12/12/18 - Added Tub Deck - 1st Floor Master (Platform Tub)

MODEL 2844

COVER SHEET

INVENTORY PROJECT
LOT 9 220 13 TH. AVE S.
SAFETY HARBOR, FL.

FIRST FLOOR

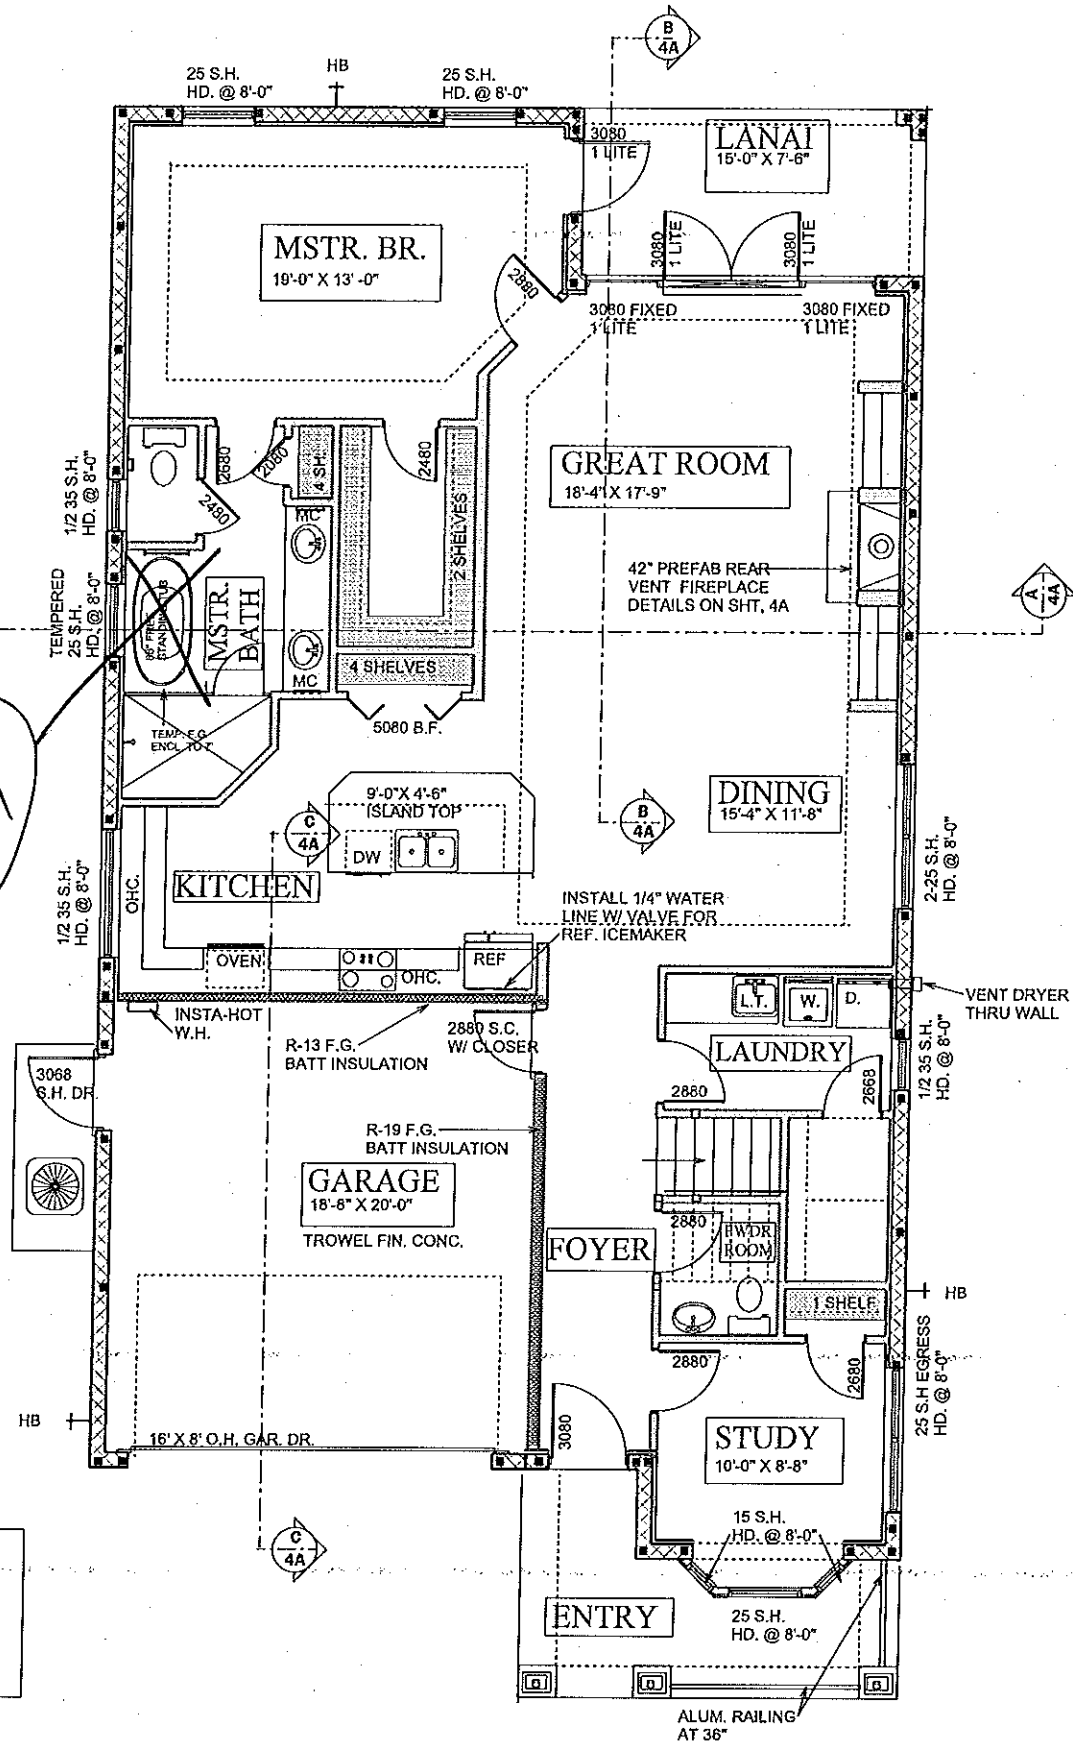
Tub See new Detail 2A

FIRST FLOOR

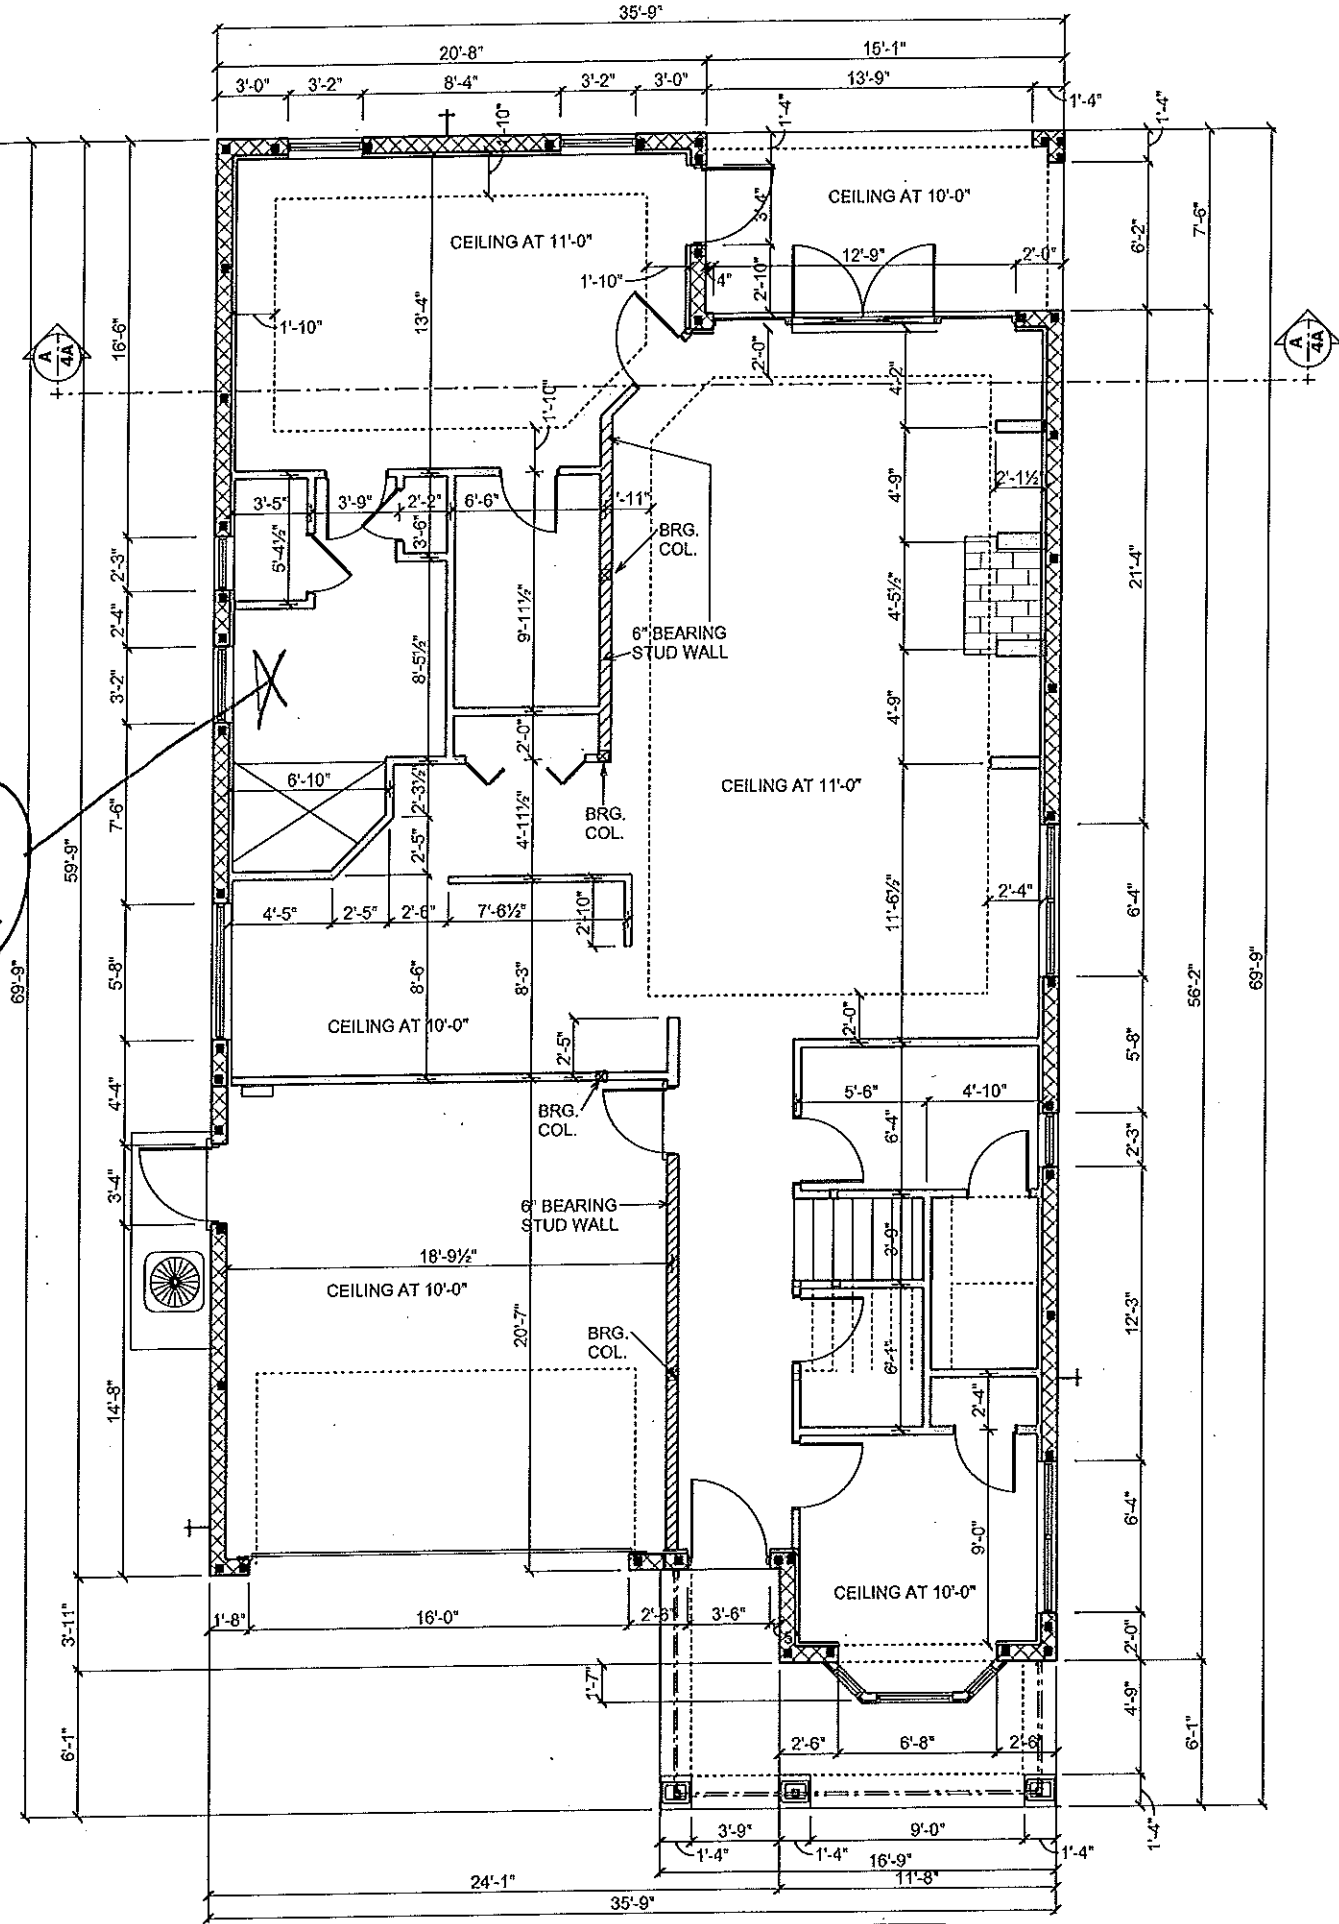
See
New
Deck
Detail
3A

FIRST FLOOR

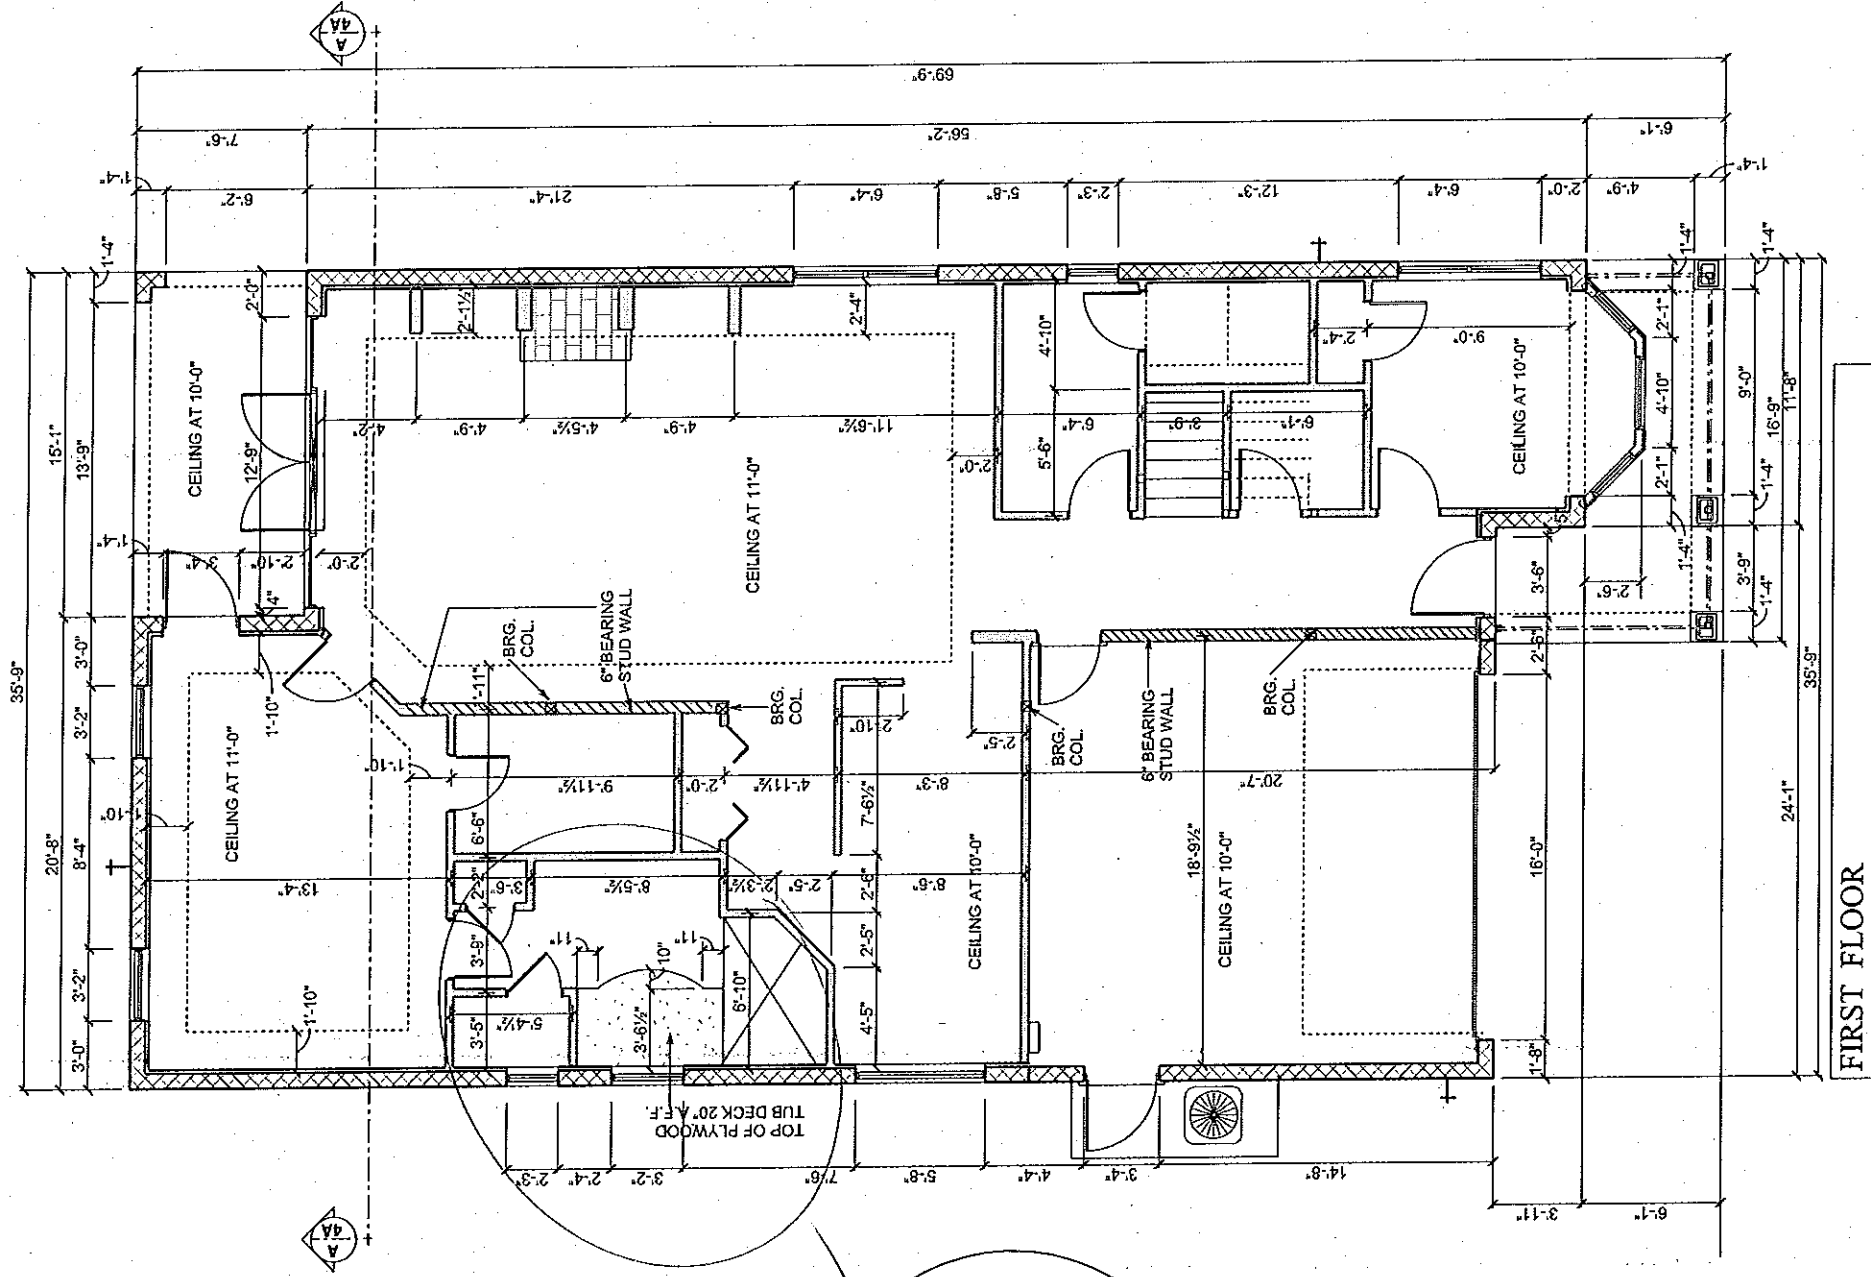
New tub
Deck
platform
TUB

RIGHT SIDE ELEVATION

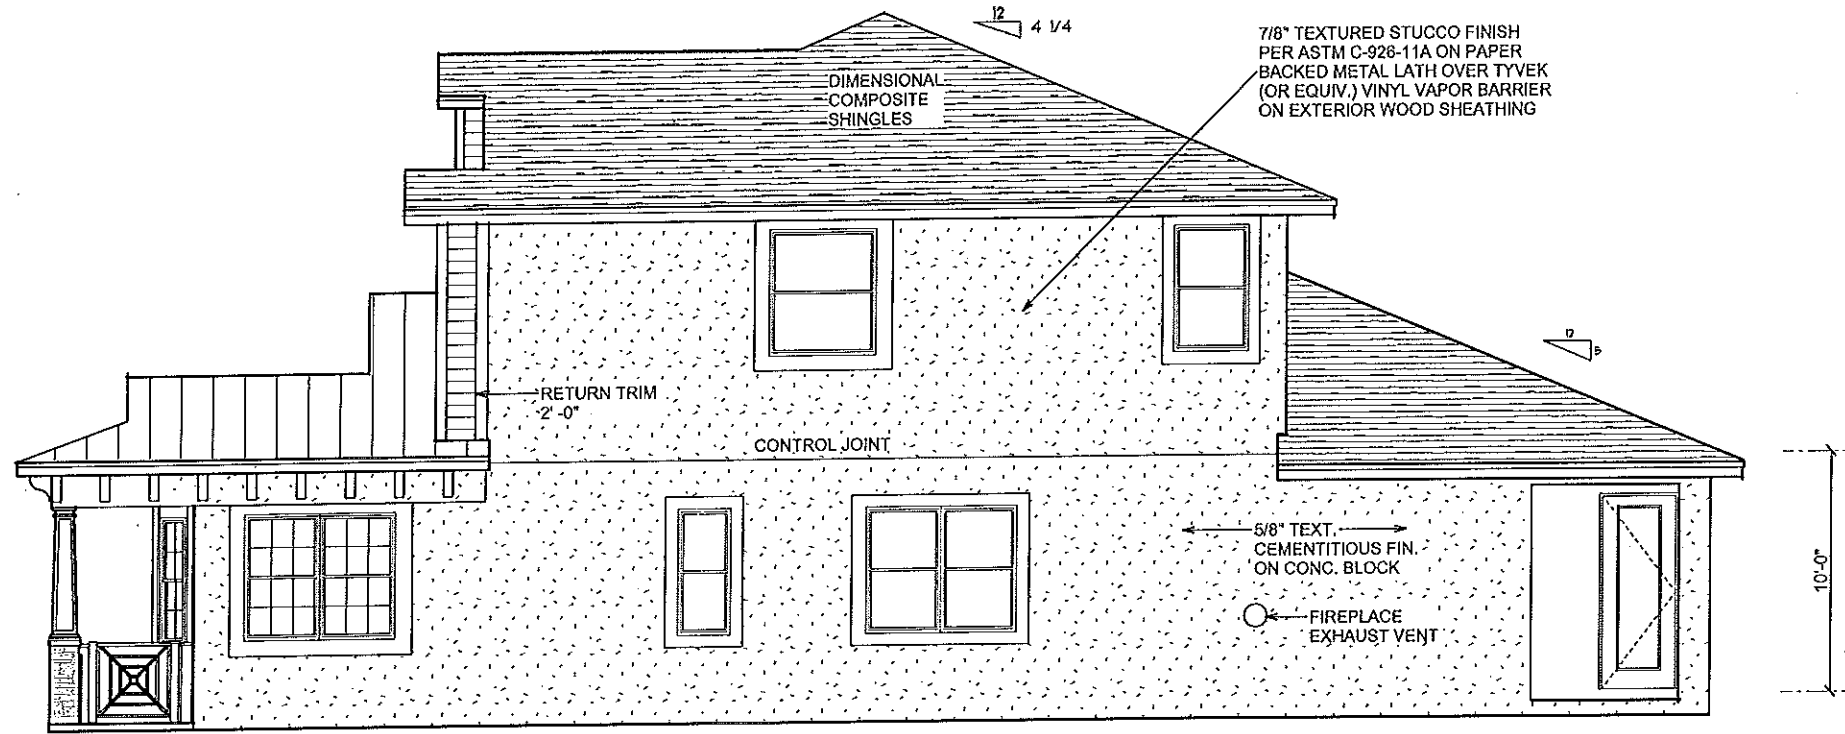
Added
TUB
Deck
3A
